| <b>Panel Reference</b>                            | <b>PPSSSH-57</b>  |
| <b>DA Number</b>                                  | DA2021/0024   |
| <b>Proposed Development</b>                       | Demolition works and construction of a mixed use development comprising retail and shop top housing.  |
| <b>Street Address</b>                             | 1-3 Wright Street and 108-124 Forest Road, Hurstville   |

Figure 15 Boundary Alignment and Land Dedication Plan (Sheet DA43)

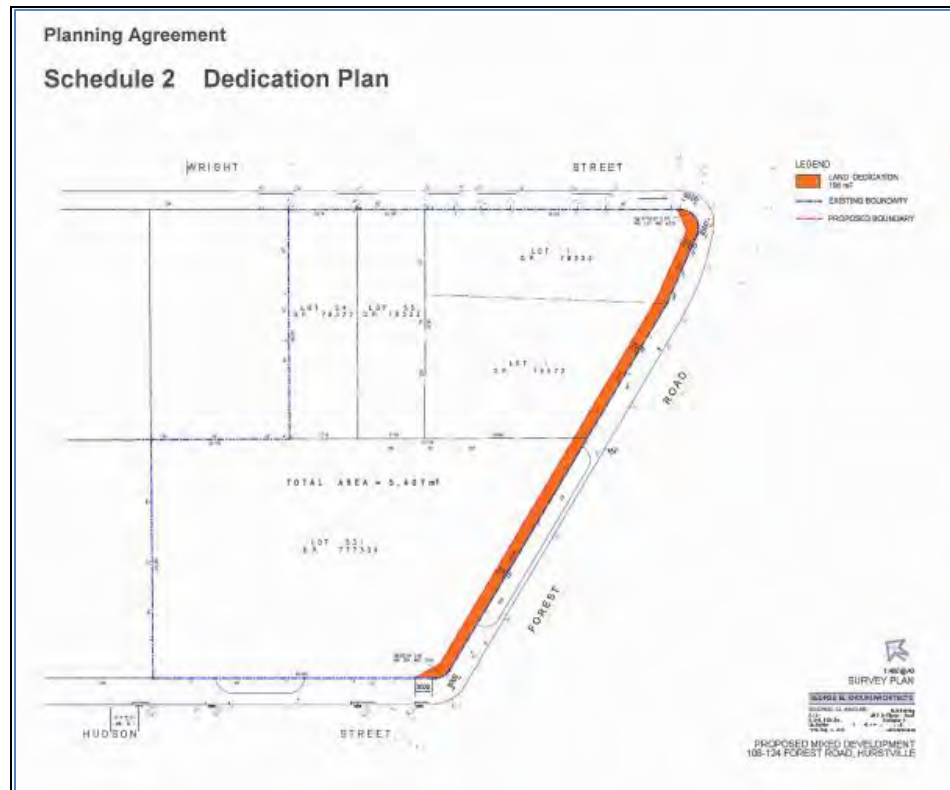
The Architectural Plans (dated 30/07/2021) and specifically the 'Boundary Alignment and Land Dedication Plan' (DA43), show the 2 metre dedication zone and new property boundary along the Forest Road frontage. The figures below provides the dedication plan from Schedule 2 of the VPA and the Boundary Alignment and Land Dedication Plan (Sheet DA43 dated 30/7/21).

**Figure 20 Height blanket diagram showing non-compliance**

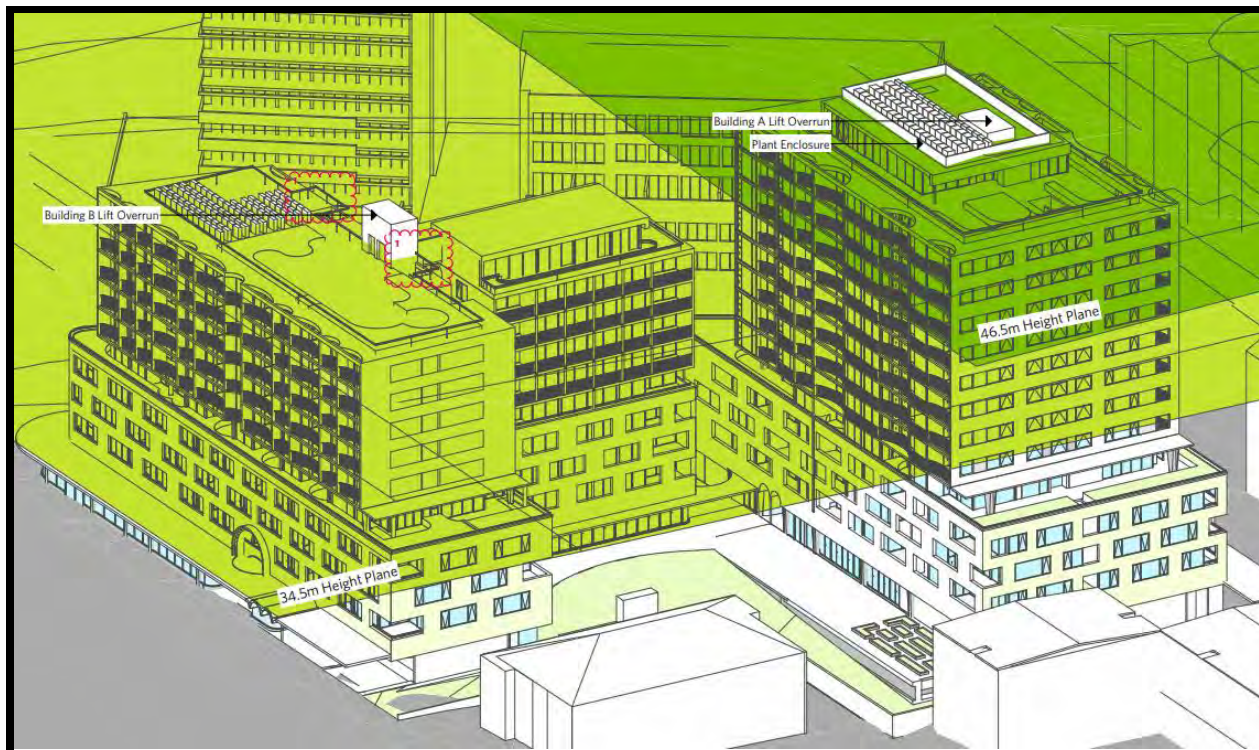
The area of non-compliance for Building B relates to the lift overrun and rooftop plant and represent a variation of 9.6%.

The following figure is a height blanket diagram indicating the extent of non-compliance.

Figure 3: Land Dedication

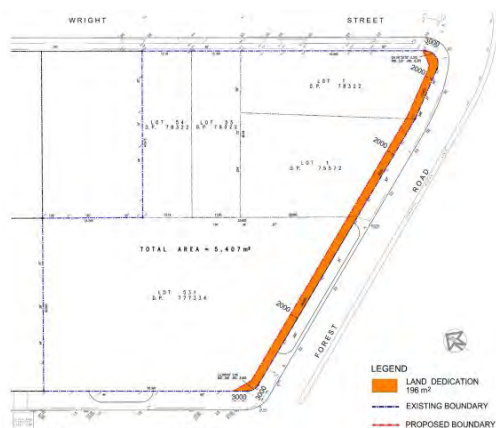
| Applicable DCP Controls  | DCP Provisions | Development Provisions  | Complies                                    |
|--|----------------|---|---|
| <p>a) Development of the site will include a dedication to Georges River Council of a strip of land of approximately 196m<sup>2</sup> and 2m wide along the Forest Road boundary, including land at Hudson Street and Wright Street at the intersection with Forest Road, for the purpose of widening Forest Road as detailed in the Planning Agreement applying to the site and as shown in Figure 3.</p> <p>b) No permanent structure may be built above or below this area of land.</p> |                | <p>The plans indicate a 2m wide dedication in accordance with the control.</p> <p>The only element proposed over this area is an awning. Given this provides public benefit via weather protection, this is accepted as the clause is considered to relate to basement and habitable floor space as opposed to awnings.</p> | <p>Yes</p> <p>No – but acceptable.</p>      |

Figure 21 4m setback non-compliance (Source SJB Peer Review, July 2021)

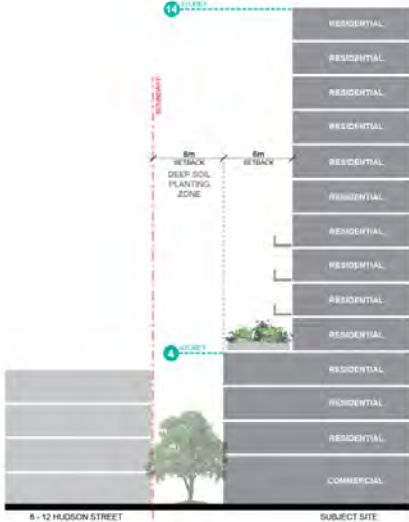
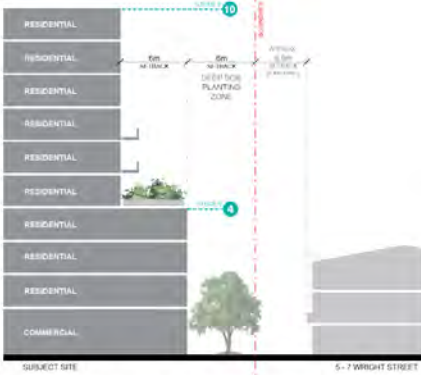
The DCP control requires a setback of 4m to the upper level/tower buildings from the Forest Road boundary. The proposal predominantly complies, with the exception of a single point encroachment at Level 5-9 in Building B as shown in the figure below:

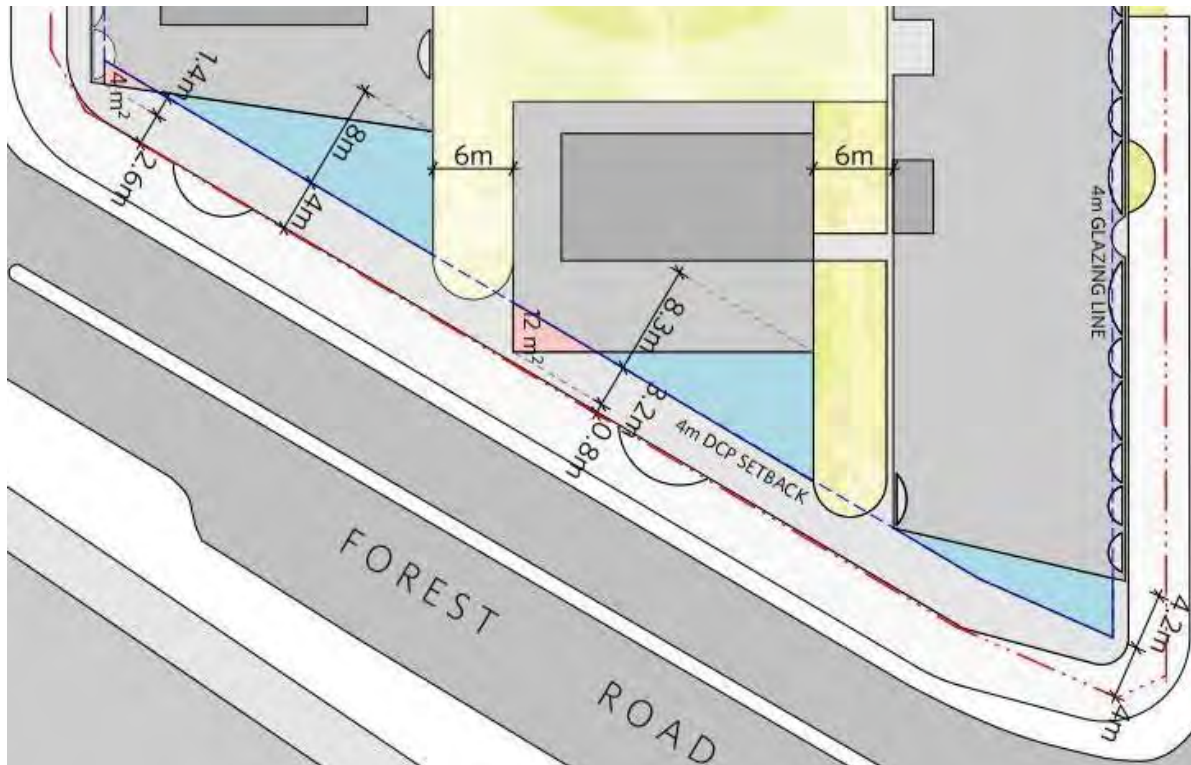
The following diagram prepared by DBJ illustrates the minor nature of the encroachment into the 4m tower setback applying to Forest Road. The encroachments are represented by the pink shading and are described below:

- A small portion of the south-western edge of Building A tower encroaches into the 4m setback by 1.4m at the corner with Hudson Street; and
- The corner of the central tower of Building B tower encroaches into the 4m setback by 3.2m, towards the centre of the site.

The encroachments are negligible and will be indiscernible given the towers are predominantly setback in excess of 4m. Tower A is setback up to 12m and the two towers forms of Building B have maximum setbacks of 8.2m and 12.3m. In this regard, the alignment of the proposed towers to Forest Road provides a larger setback on average than the minimum 4m setback required by the HDCP No. 2.
